FIELD CHANGE DIRECTIVE
No. 10-Rev. 1

PROJECT: Truman Waterfront Park Phase 1A

FCD-10 Hardscape Revisions

August 22, 2016

WINDOW 4

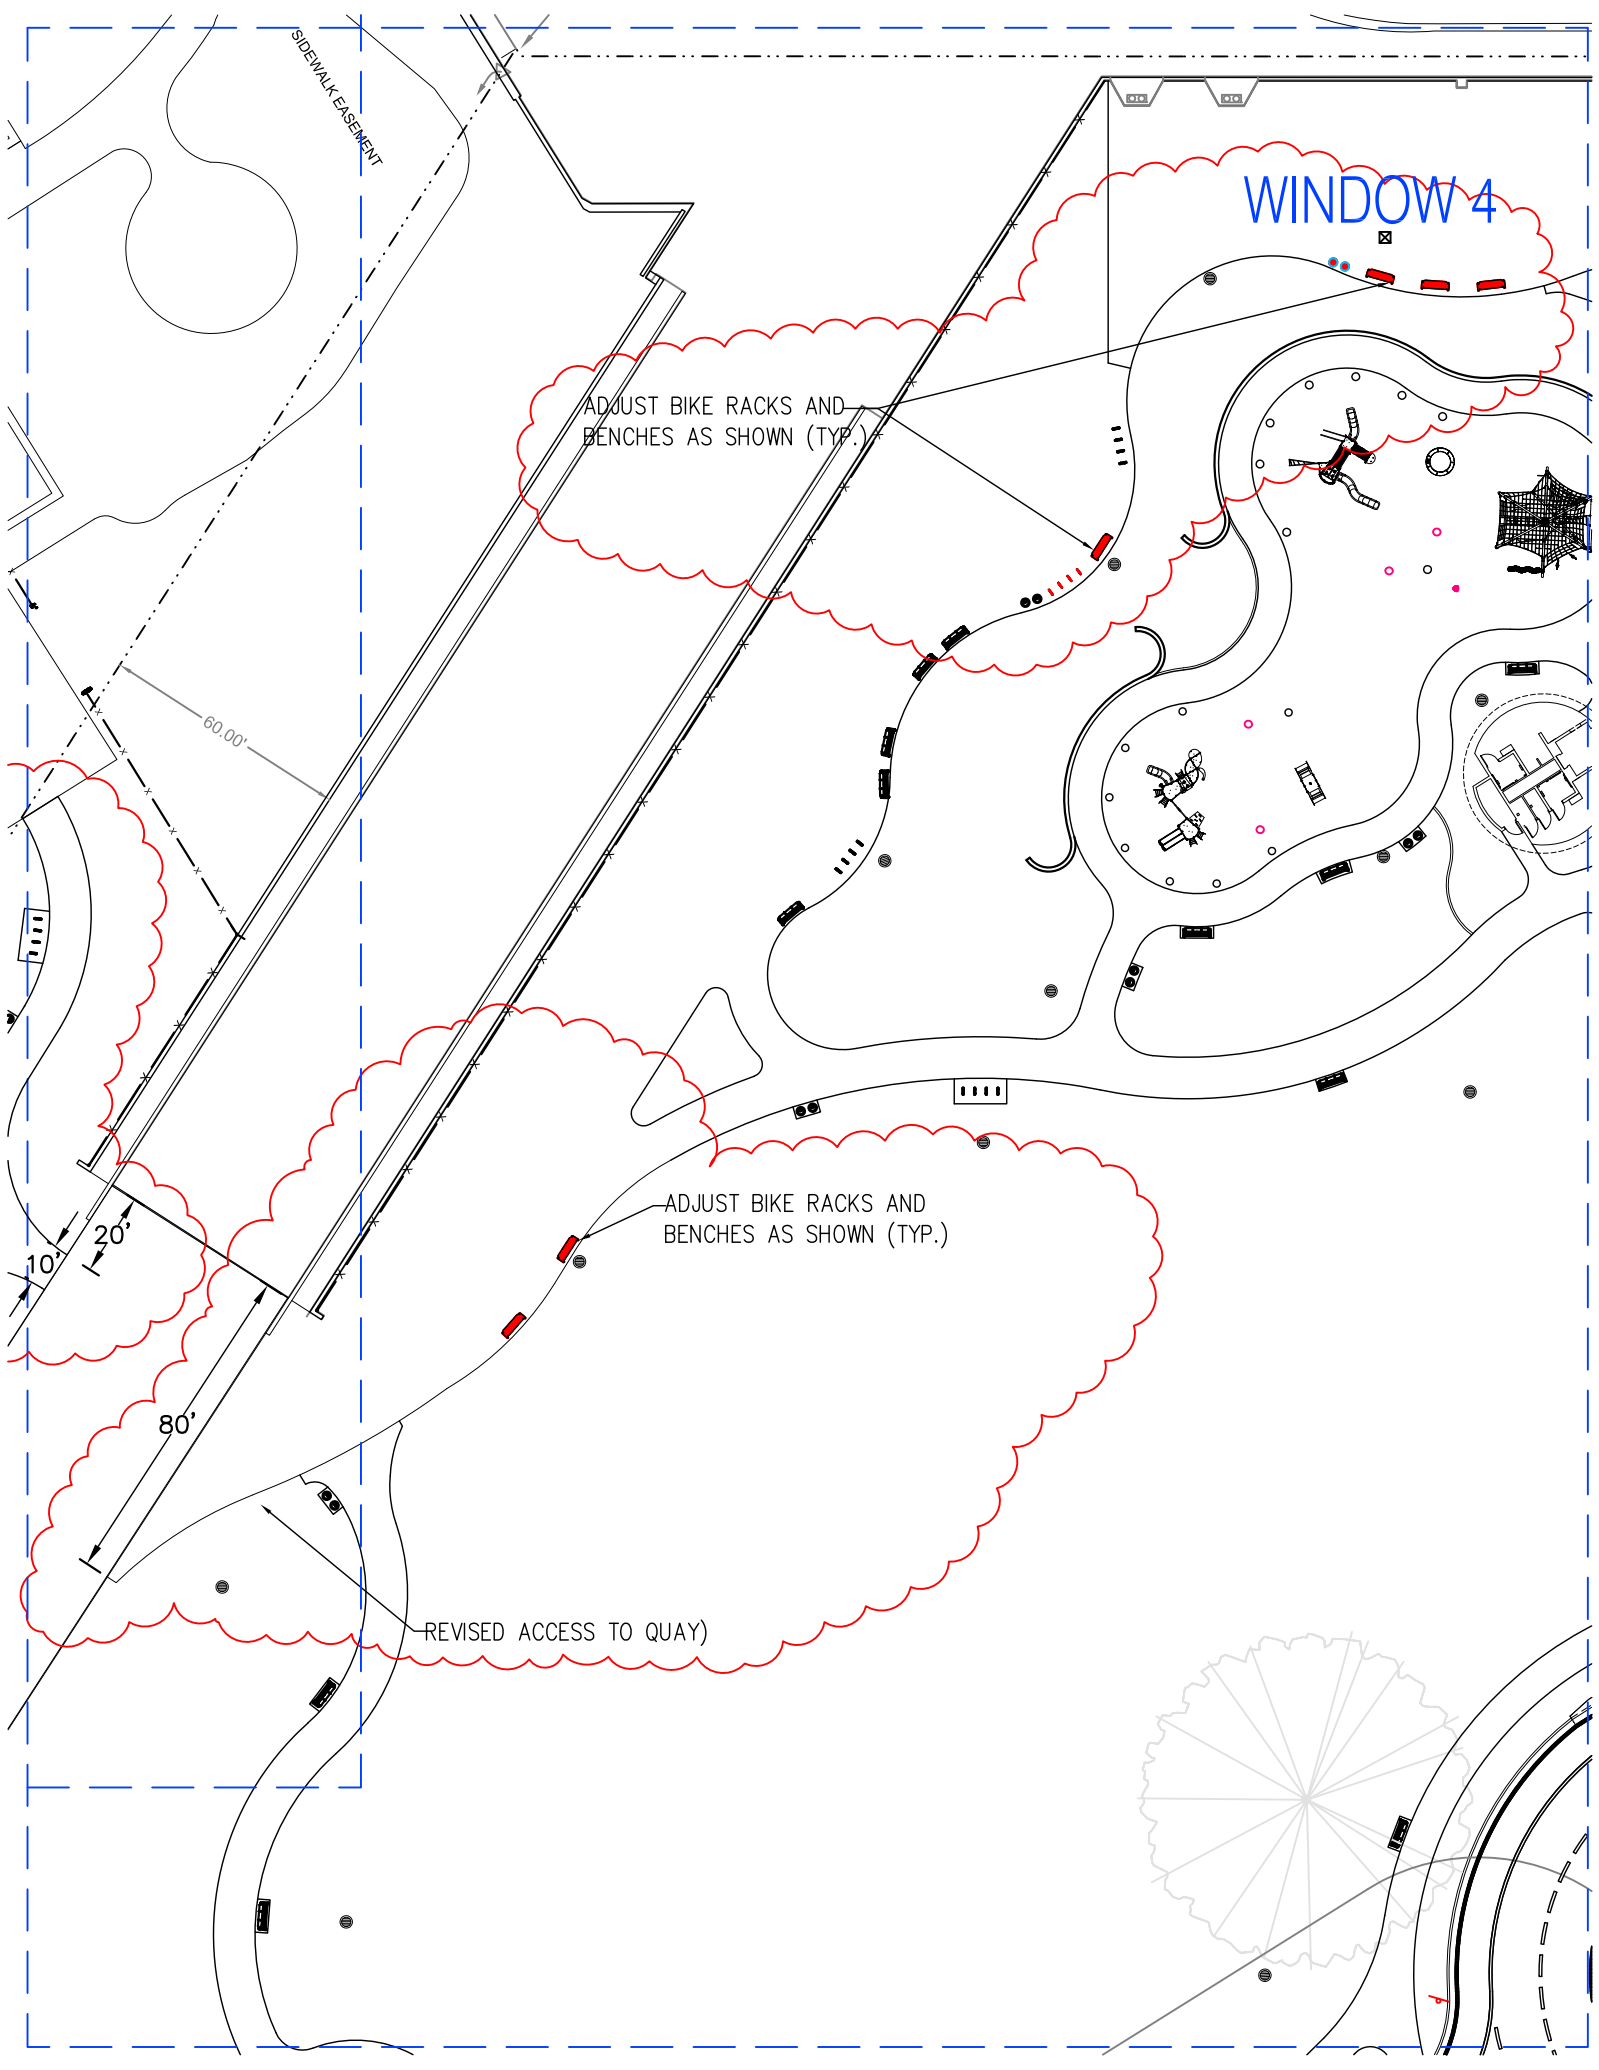
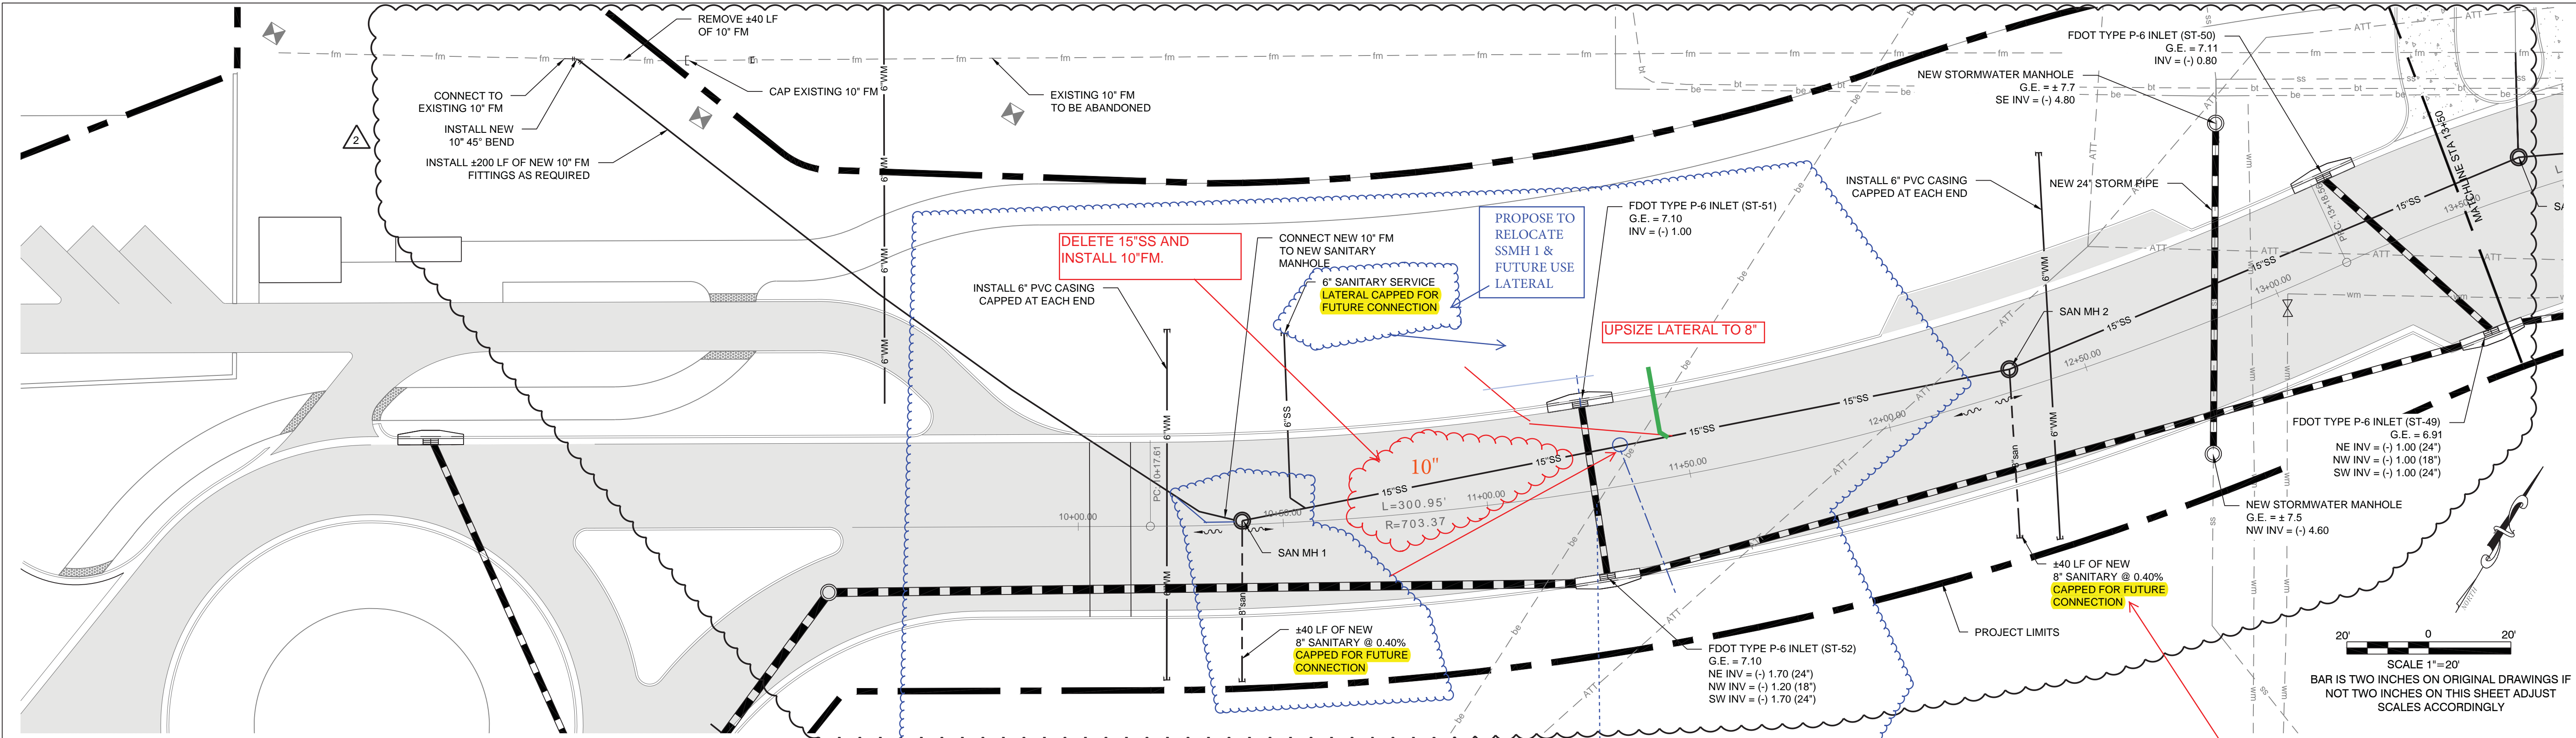
ADJUST BIKE RACKS AND
BENCHES AS SHOWN (TYP.)

ADJUST BIKE RACKS AND
BENCHES AS SHOWN (TYP.)

REVISED ACCESS TO QUAY)
